HOWELL TOWNSHIP PLANNING COMMISSION

REGULAR MEETING

3525 Byron Road
Howell, MI 48855
December 16, 2025
6:30 pm

- D. Resignation of Mike Newstead
12. Business Items
 - A. Old Business:
 - B. New Business:
 1. Dakota Haslock, PC2025-22, 3590 W. Grand River Ave., Parcel # 4706-28-100-024, Preliminary Site Plan Review

SHEET NUMBER
C5.3

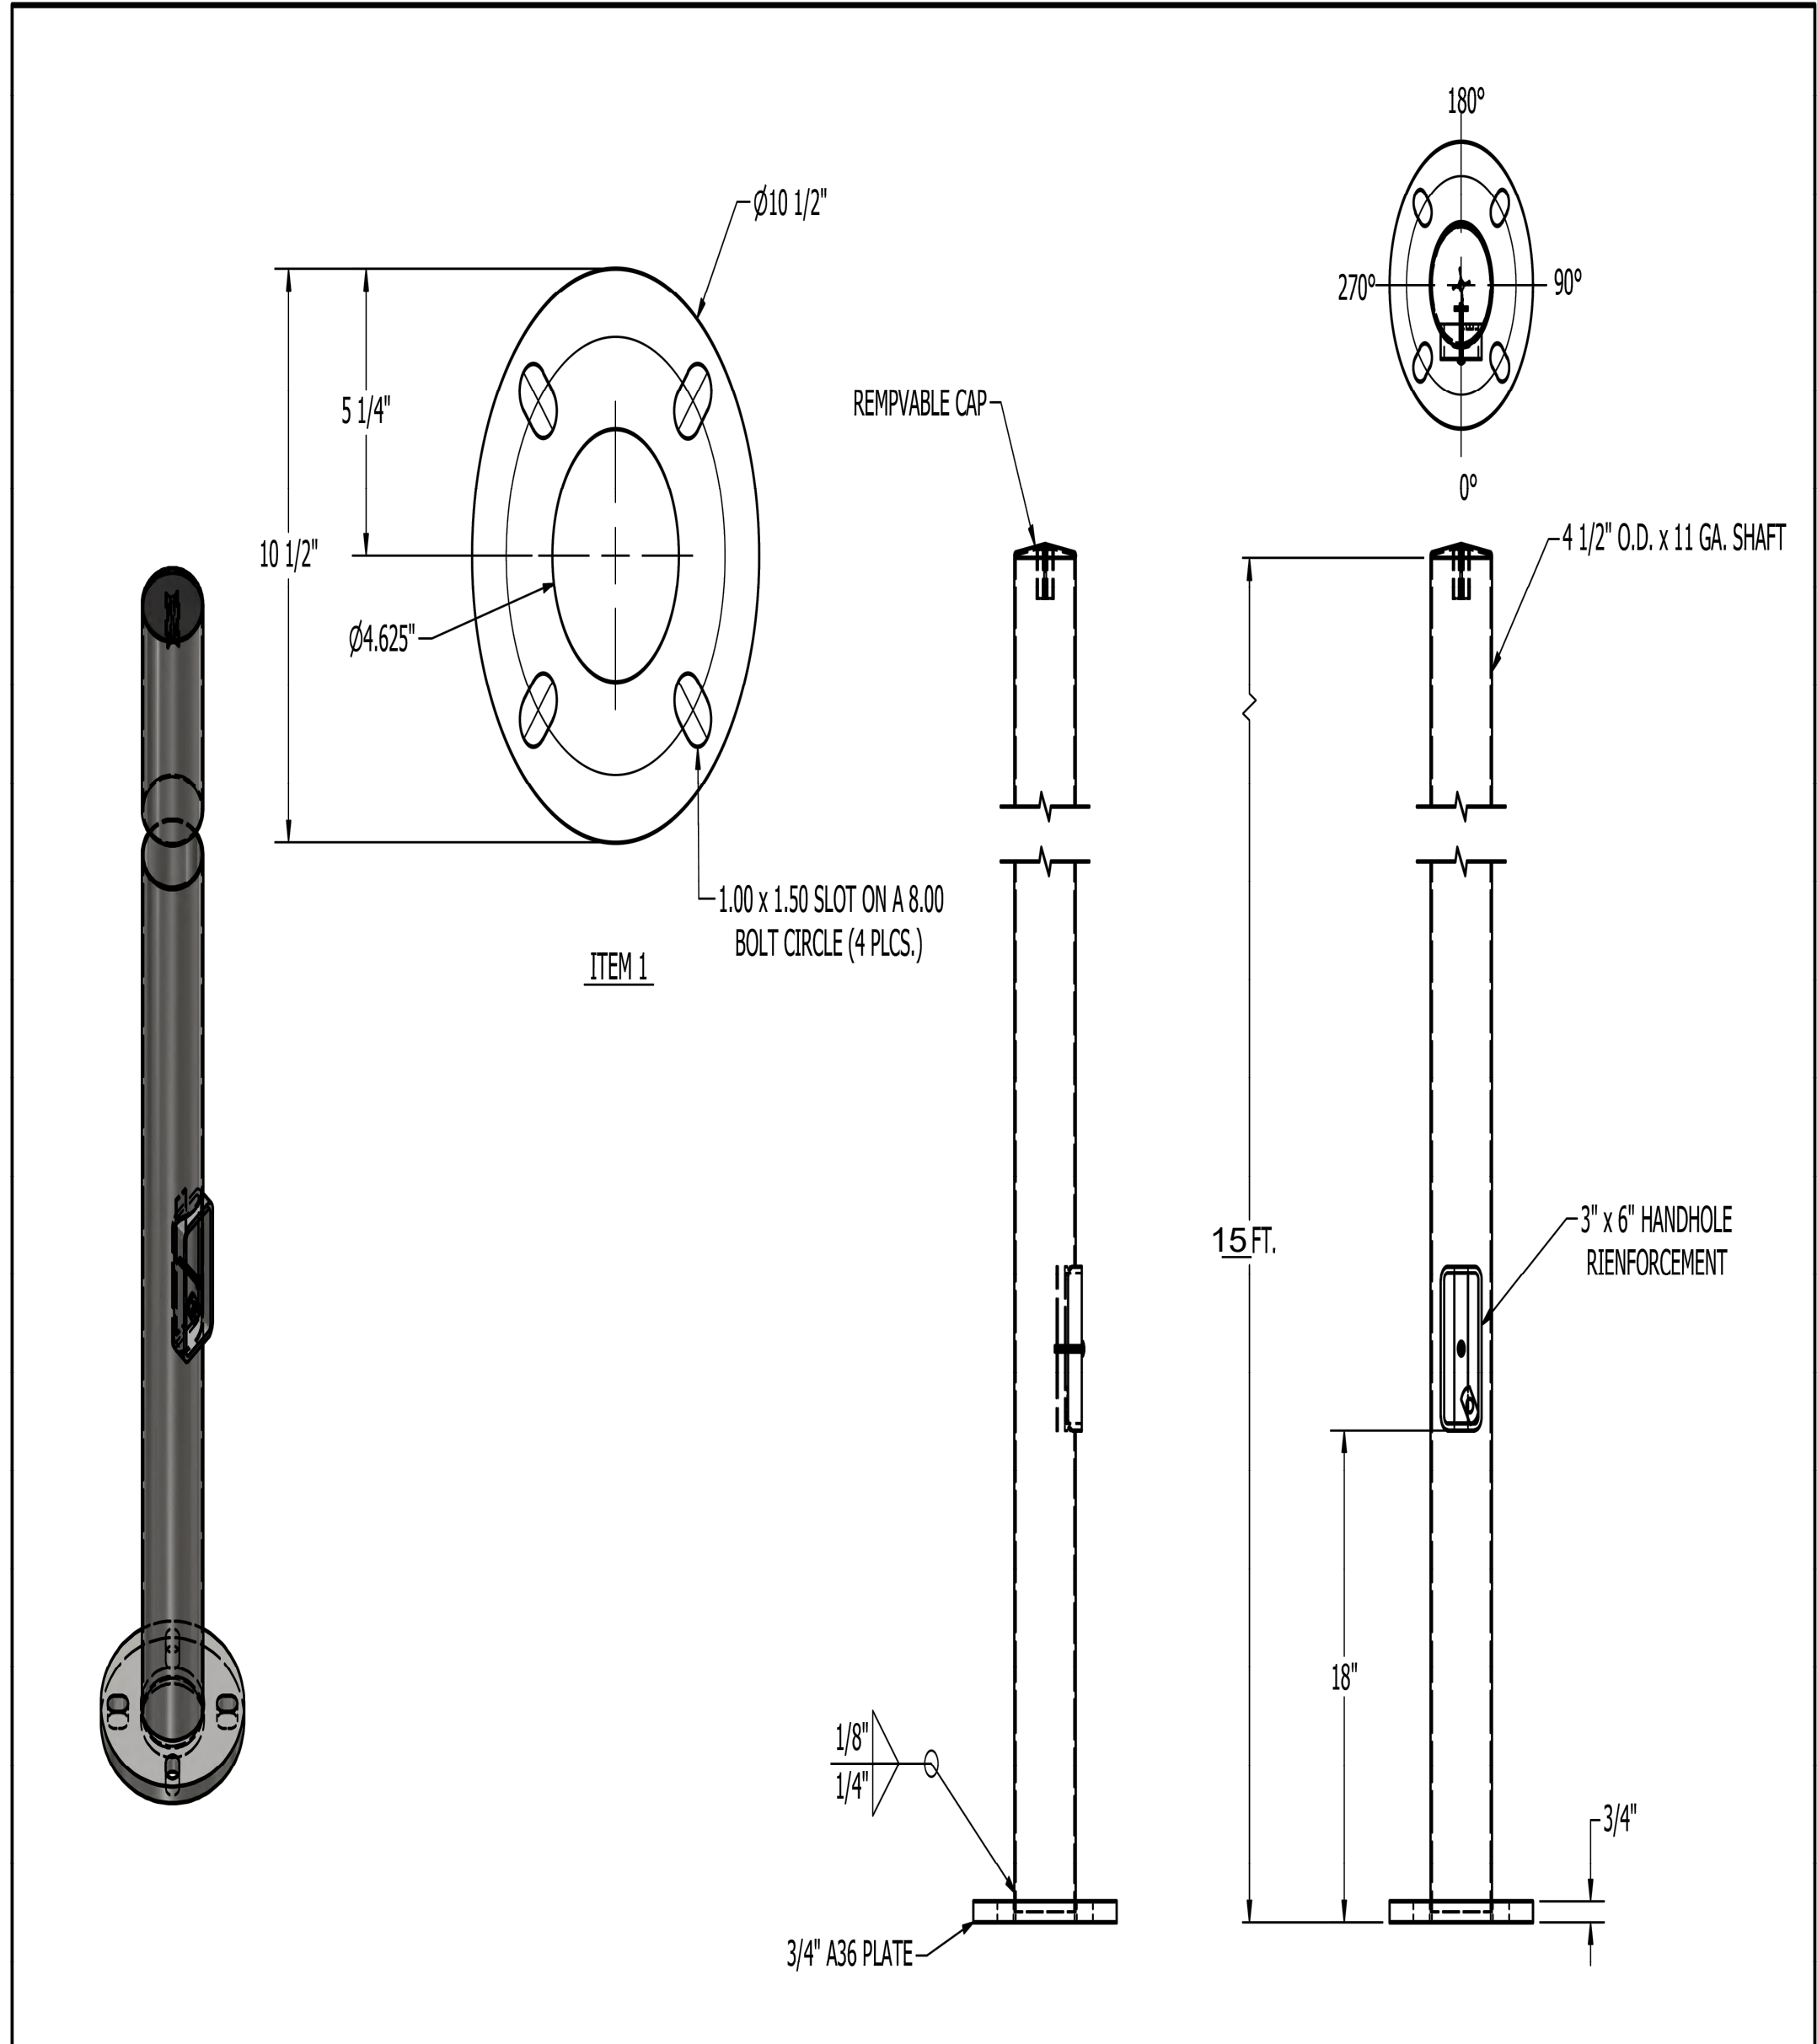
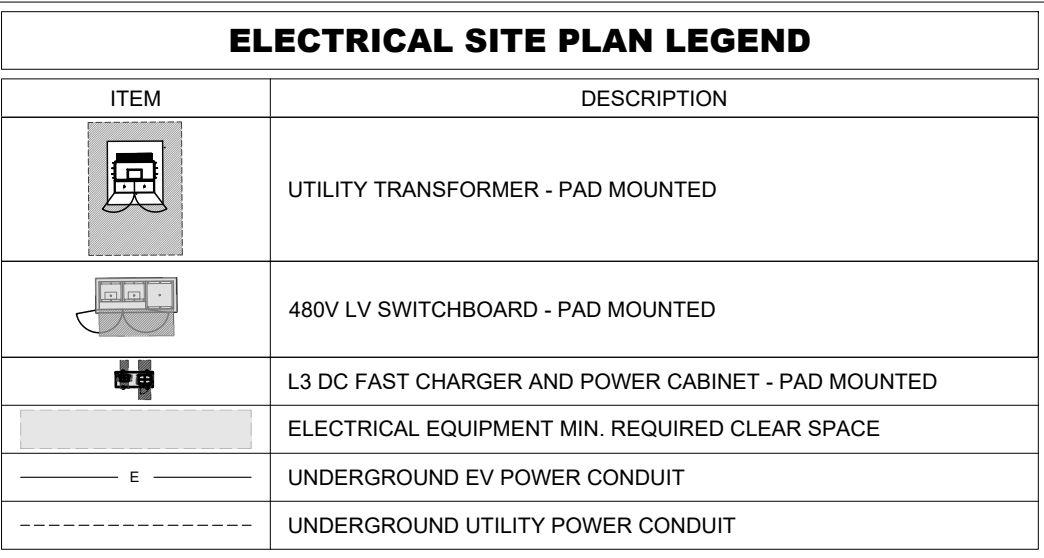
The applicant is also proposing to add 2 light poles within the parking stalls. Additional details can be found on Sheet C5.2 and C5.3. The light poles are proposed to be operational 24/7 with motion detecting sensors. The proposed light fixtures have flat recessed lighting elements and are downward directed. There are no concerns with the lighting being proposed.
